308 - - - Q200008310004
Scientific Notebook # 350

201405031
Assessment of CISF TSAR
Doug Gute 210.522.2307

Safety Evaluation of HI-STAR/HI-STORM Casks for High Seismic Sites

The objectives of this task are to support the NRC in reviewing the DOE centralized interim storage facility (CISF) topical safety analysis report (TSAR), developing an assessment report (AR) for the CISF, and reviewing a Holtec International Topical Report (TR) covering the use of the HI-STAR and HI-STORM spent fuel storage casks and anchorage systems in unspecified areas of the country that are considered to be "High Seismic Activity Areas." See the Operations Manual for more detailed information regarding the proposed approach and procedures for achieving these objectives.

Clevis Bolt Spring Constant Approximation

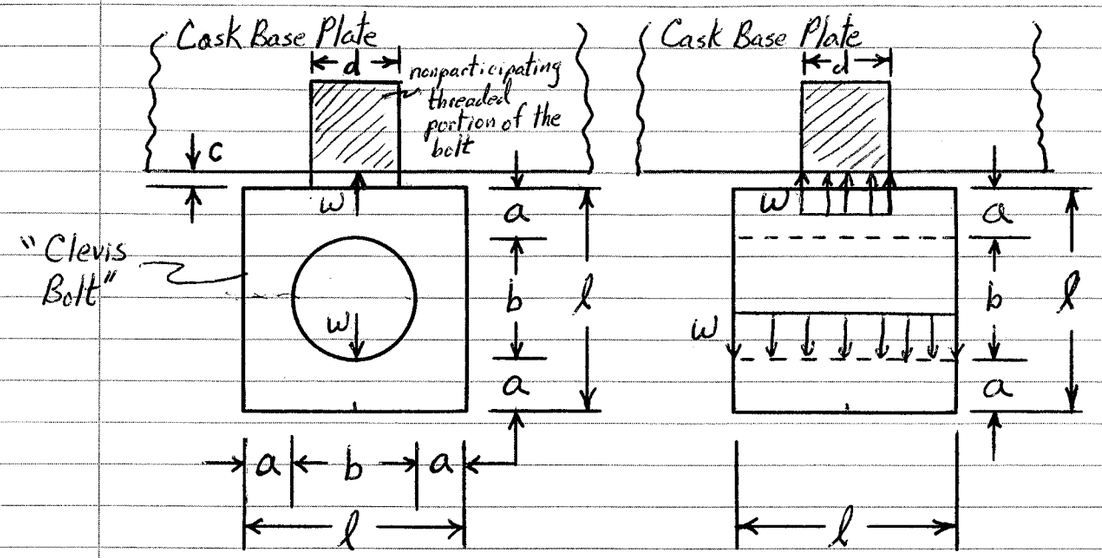
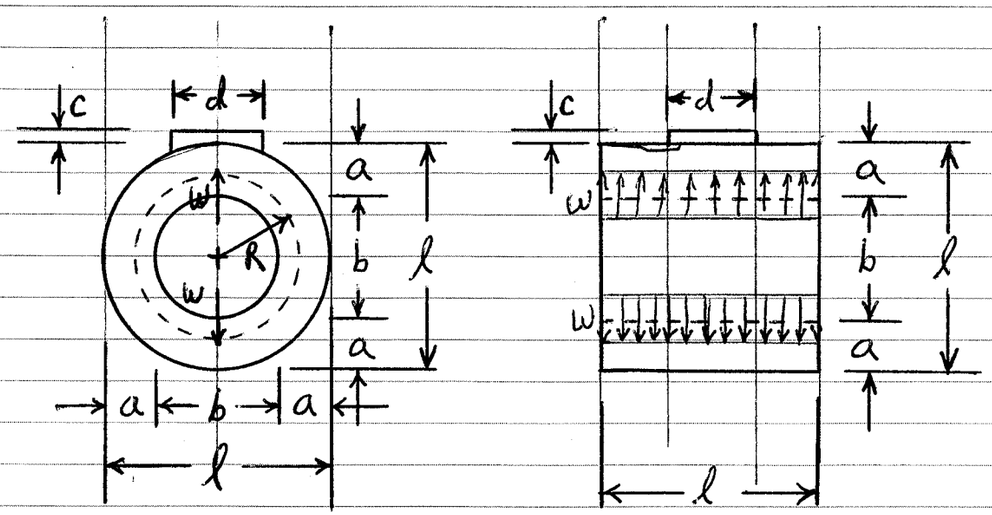
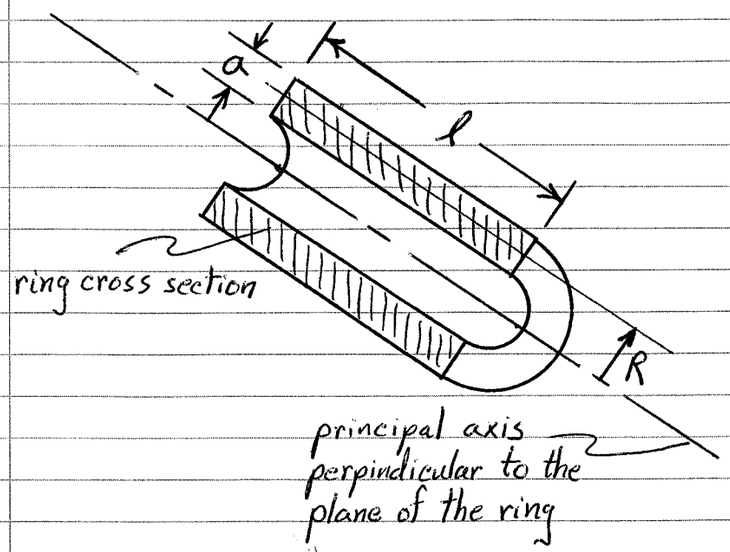
; Formulation for I is in error! See correction on p.6. Doug Tate, 12/27/99

Note that this spring constant is 18 times larger than the "Bolt Spring Constant" calculated in the TSAR (i.e., $K_{bolt} = 2.56(10^7)$).

Upon review of the I formulation given on p. 4, eq'n (5), it was found that a mistake was made. The correct form is given below:

$$I = \frac{1}{12} l a^3$$
$$= 1.4543 \text{ in}^4$$

$$K_{block} = 2.5947(10^7) \text{ lb/in}$$

$$K_{TOTAL} = 2.5369(10^7) \text{ lb/in.}$$

Clevis Pin Spring Constant Assessment

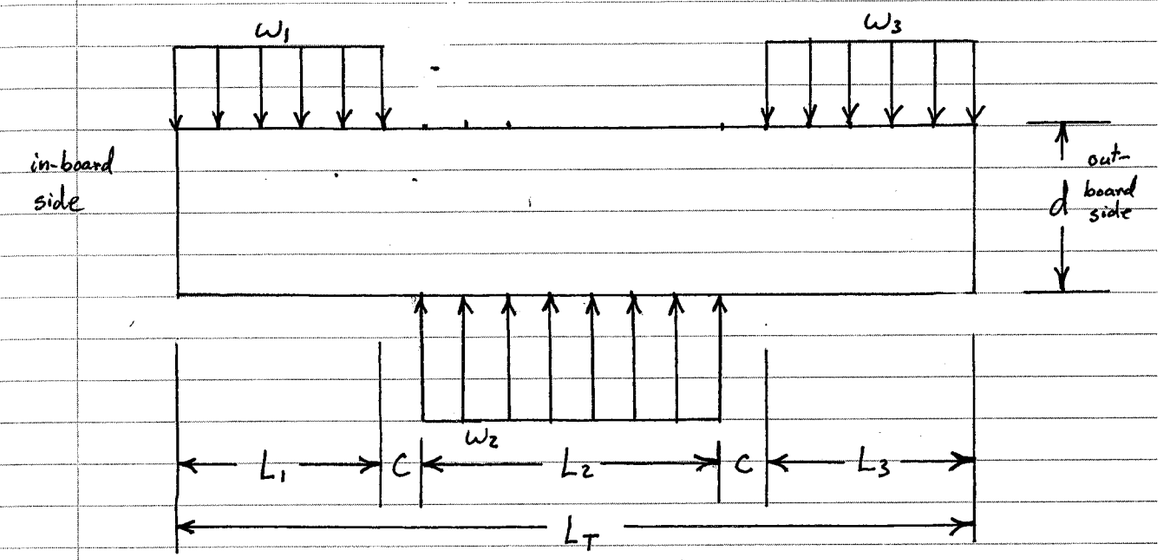
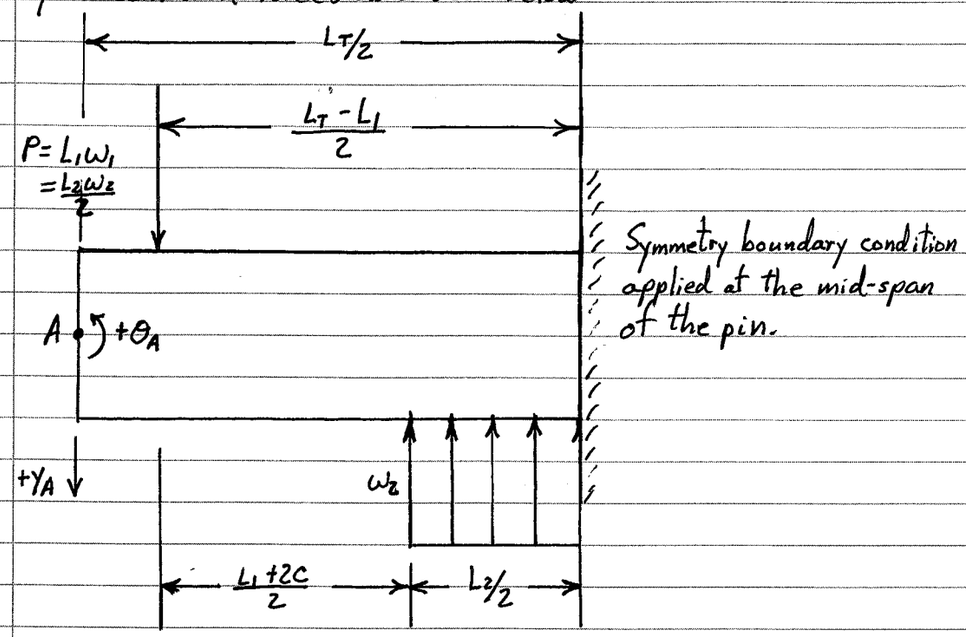
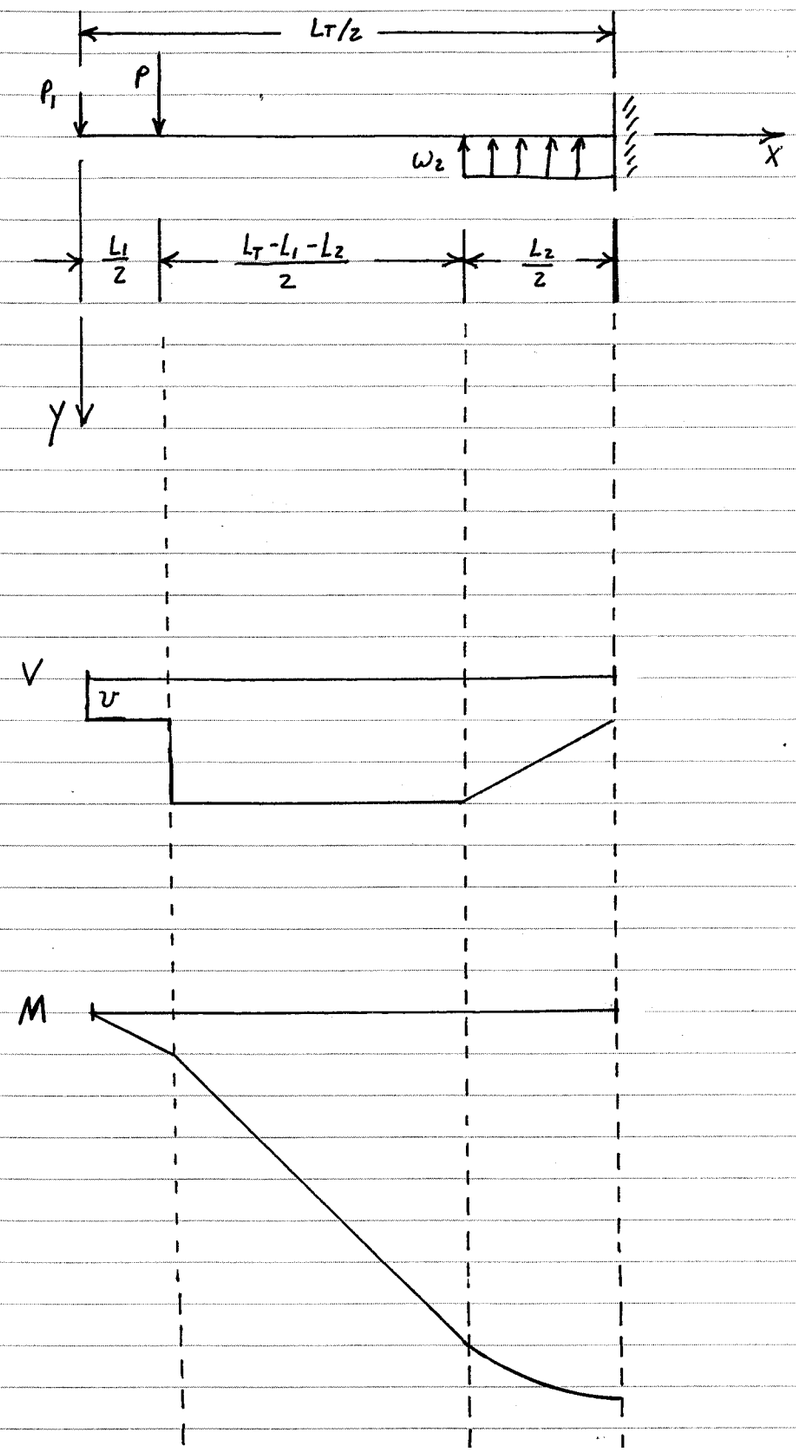
Assess the influence of a uniformly distributed load as opposed to the concentrated couplesassumed in the Holtec Topical Report.

Note that this result is substantially smaller than that derived in the Holtec TR, i.e. $K_{pin} = 3.1(10^8)$ lb/in.
